Our Ref: ABP-301908-18

Re: Greater Dublin Drainage Project consisting of a new wastewater treatment plant, sludge hub centre, orbital sewer, outfall pipeline and regional biosolids storage facility  
Townlands of Clonshagh, Dubber and Newtown, County Fingal and Dublin City

***Re: Proposed four Wastewater/Sewage Storage Tanks of 5 million litres each in front of Connolly Hospital and sewage pumping station in Abbotstown along with orbital sewage pipe to Clonshaugh North Dublin***

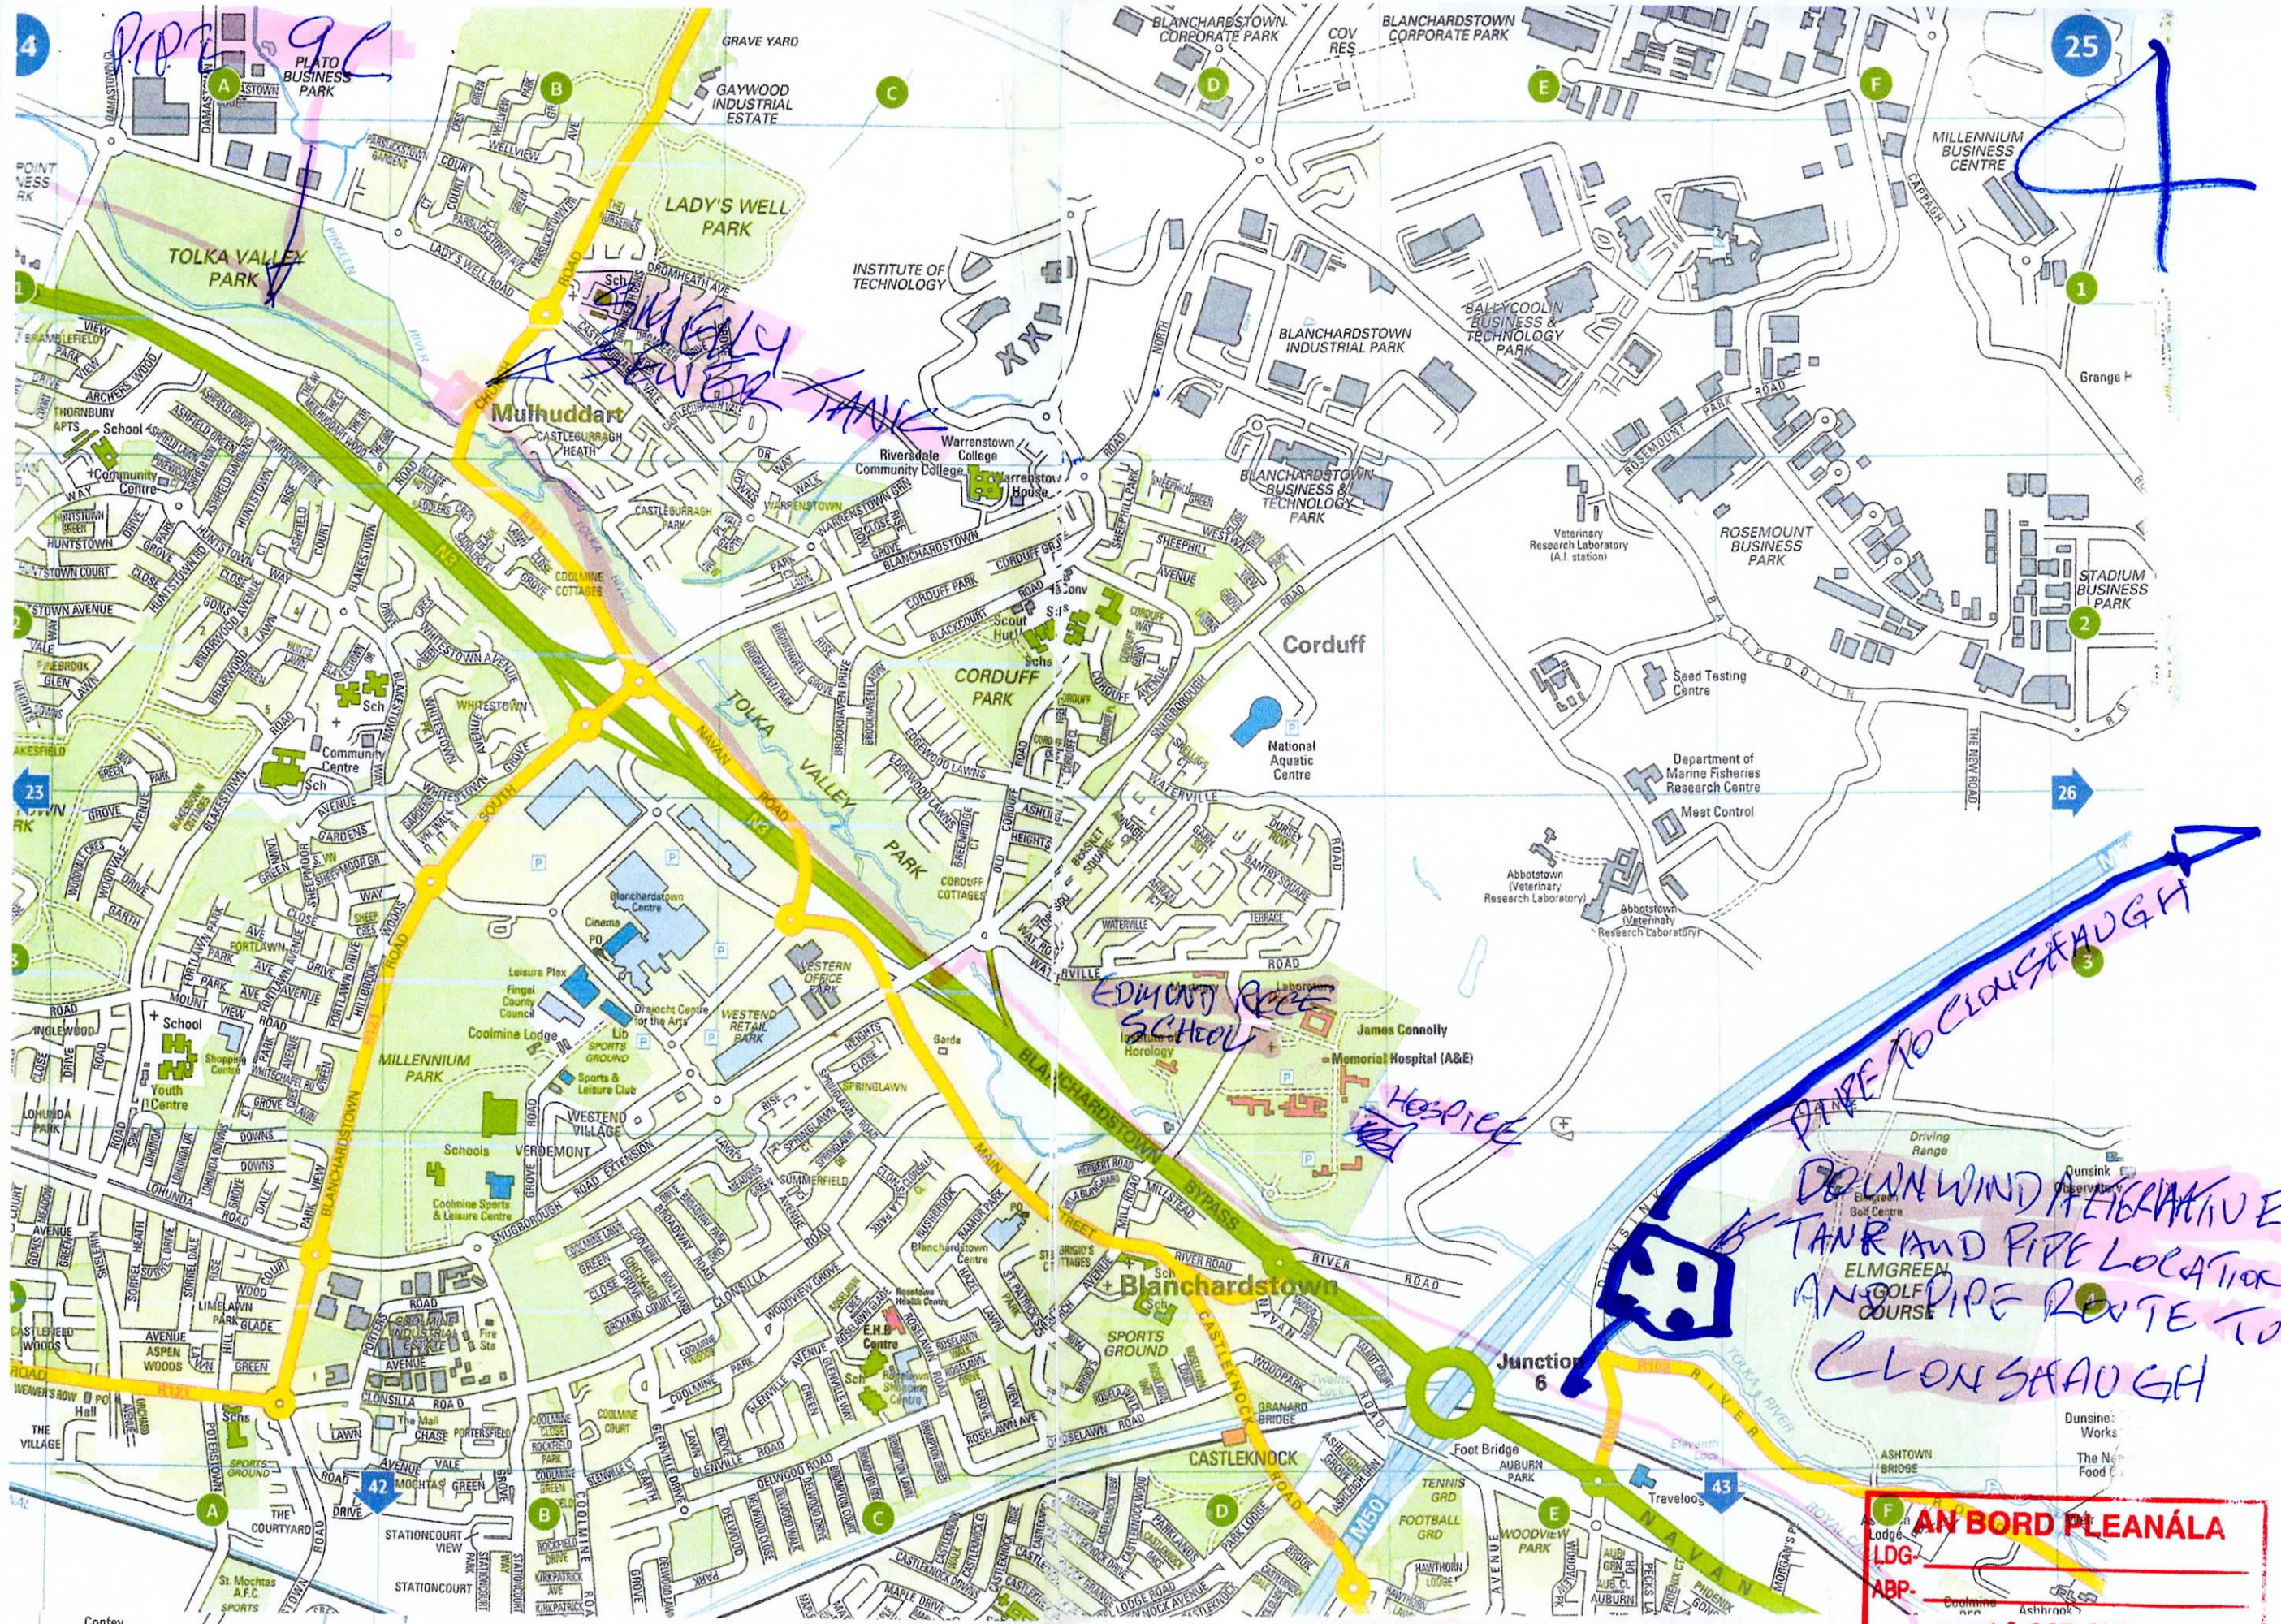
Many of the aforementioned issues raised could be ameliorated if interception of the existing sewer pipe 9C was to take place East/South of the M50 as indicated on Map 4, where the pumps and tanks would be away from patients, staff and community. Dunsink Lane could be used by the service tankers, which would have direct access to the N3.

The alternative pipeline route to Clonshaugh running parallel to the M50 would cross mainly public lands, be shorter, more direct and at a lower OD level, thus, reducing construction and running costs to commercial rate and residential property taxpayers. *See Map 4 and 4A*

# Land Profile at Hospital Location

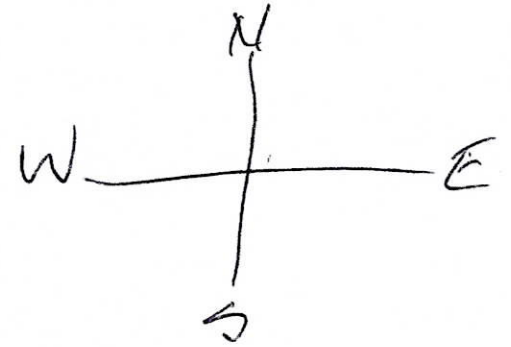
1. The close proximity of tanks approximately 200 metres West of Connolly Hospital, the Children's Hospital, St Francis Hospice and the surrounding densely populated community, the Edmond Rice School and the town centre. The continuous hum from the motors and transformers. *See Map 1*
2. The sheer volume 20 million litres of sewage stored at this location and the volume of gases produced, which include; carbon dioxide, methane, ammonia and hydrogen sulphide which will blow directly across the hospital, school and hospice. Each tank has an 8-metre high forced draught ventilation shaft. *See Sketch 2*
3. The sewage storage tanks will have to be cleared of debris on a regular basis.
4. The tanker taking the debris away from the storage tanks and pump screens will travel by the hospital and densely populated areas with the risk of foul smells.

Prevailing Wind Direction  
is from the West

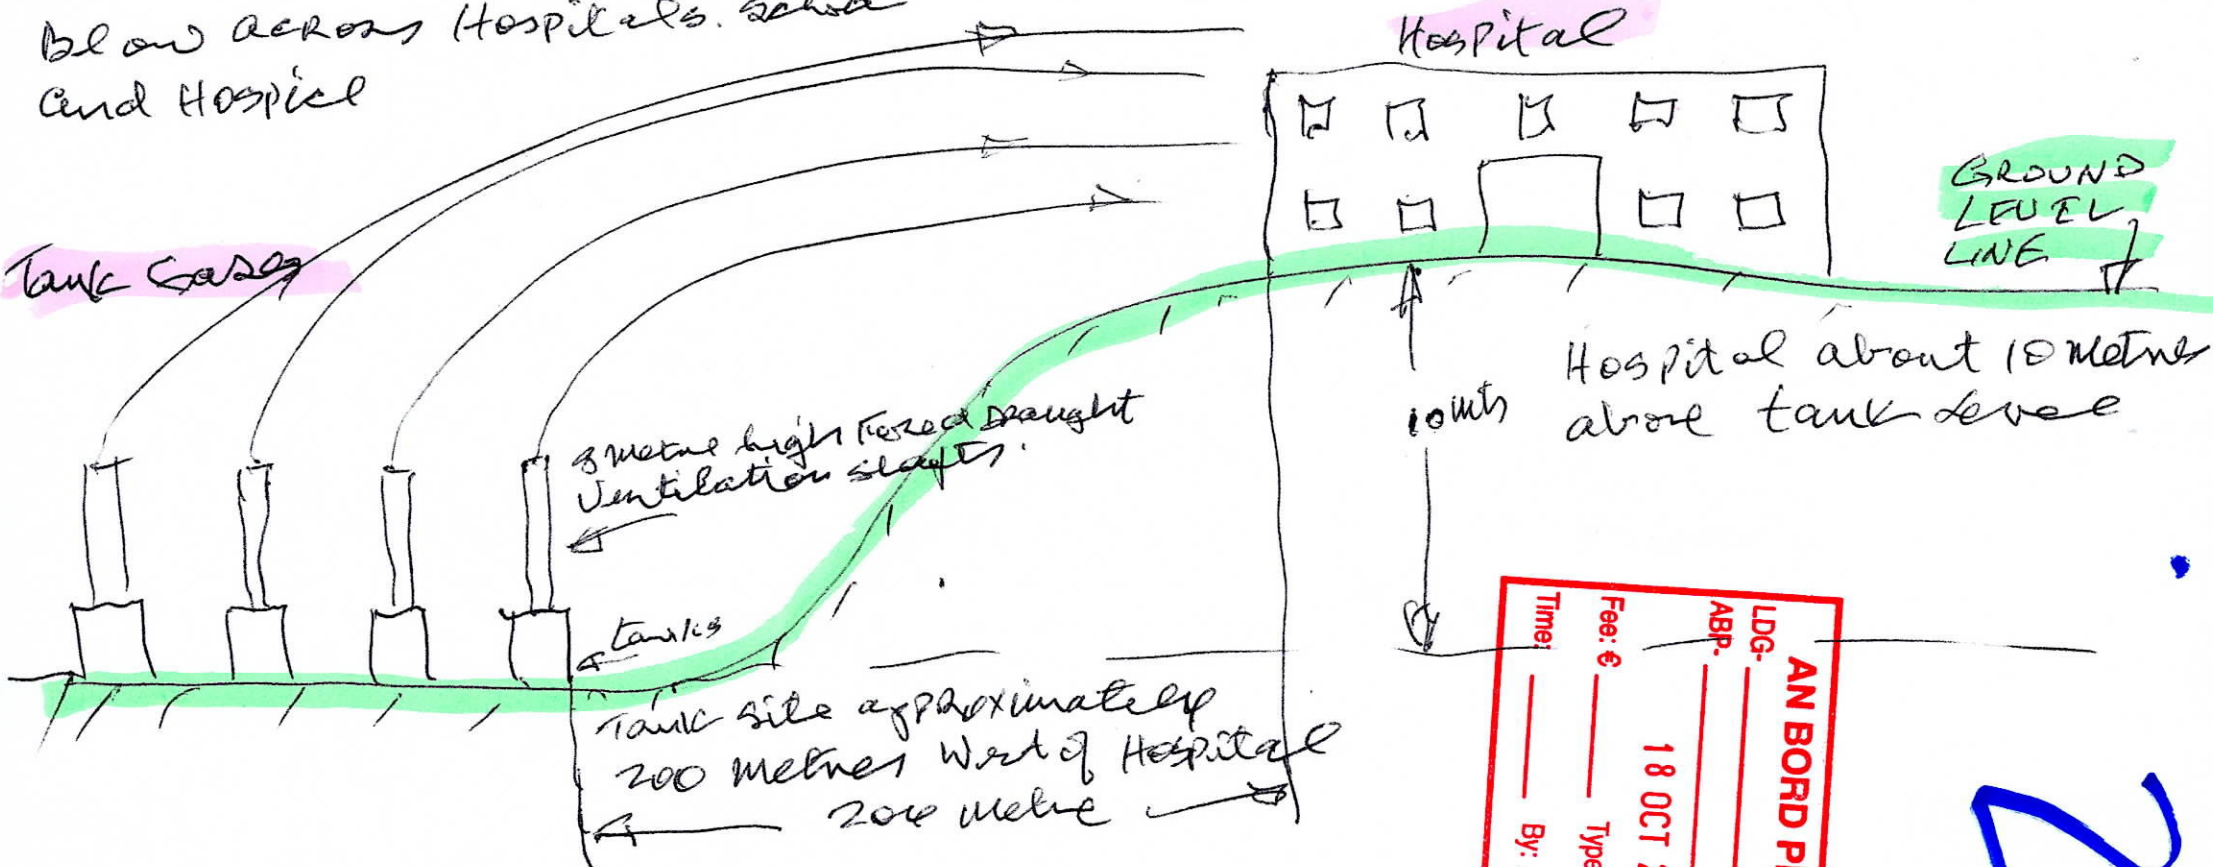
Gases from tanks include Carbon Dioxide,  
Methane, Ammonia, and Hydrogen Sulfide  
Blow across Hospitals, School  
and Hospital
